CONDITIONAL USE PERMIT APPLICATION

To: **Planning Commission**
From: **Melissa Sonnek, City Planner**
Date: **July 21, 2020**

CUP, Site Plan, Rezoning, and Plat for 1201 Robert St #50 and 100 Signal Hills Ave

Case 20-07 – Site Plan Review for the Construction of Two Apartment Buildings

Site Access – Butler Avenue

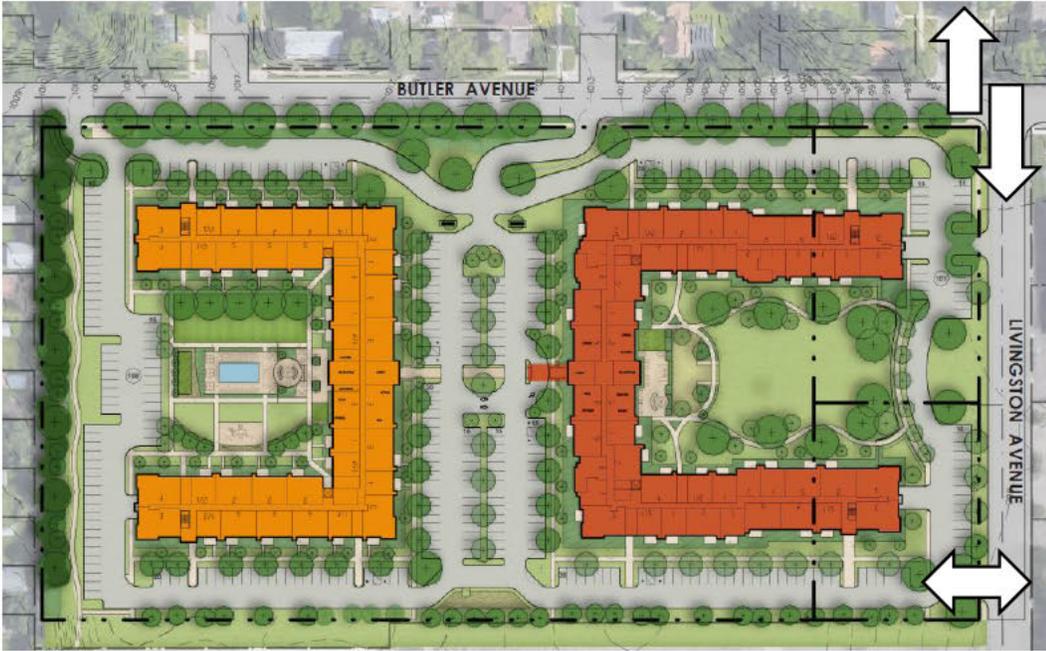
The existing site west access behind the K-Mart building was requested by Dakota County to be closed, to decrease the number of curb cuts and the amount of potential intersection conflict. The primary access to the site from Butler Avenue will be just south of where Gorman Avenue intersects with Butler.

Figure 1 – Peak Hour Site Trips with Current Land Use Scenario

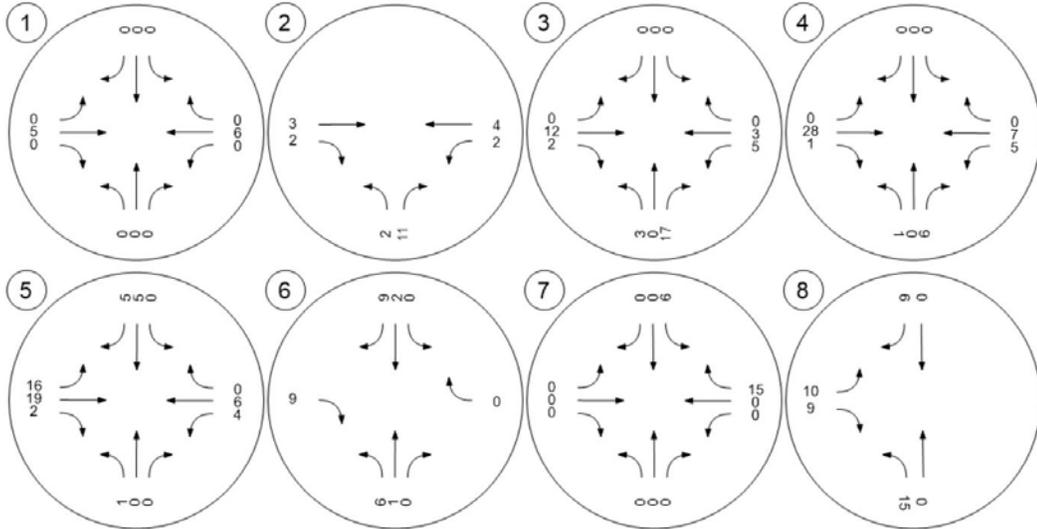
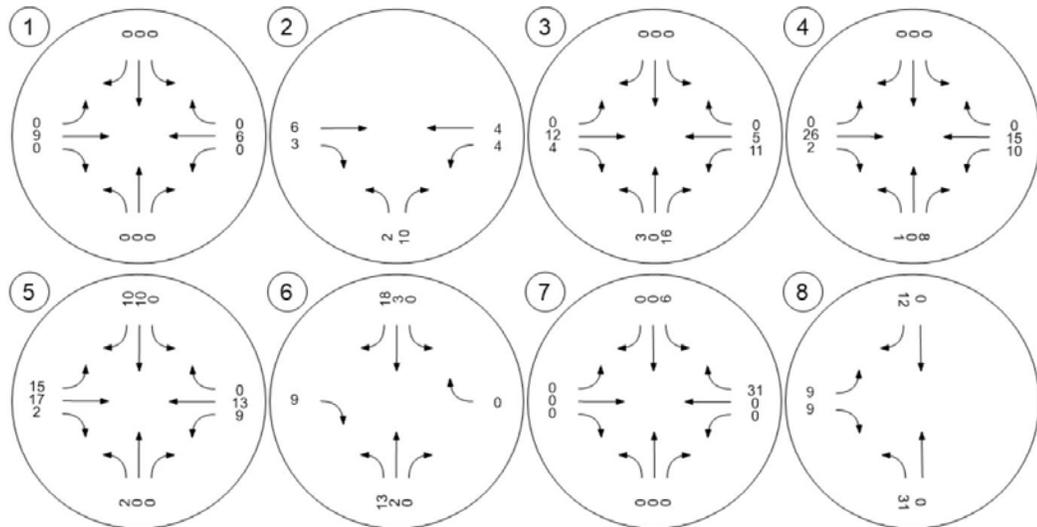
As seen in Figure 1, the highest hourly volume increase for any intersection movement due to the site traffic is 31 vehicles. This occurs at the westbound right turn at Livingston Avenue & Orme Avenue and the northbound left turn at Livingston Avenue & Site Access in the evening peak hour. This magnitude of new trips equates to an increase of roughly one vehicle every two minutes for that movement.

This magnitude of new trips at one intersection does not raise any significant impact concerns and is not expected to significantly change overall traffic flow or operations.
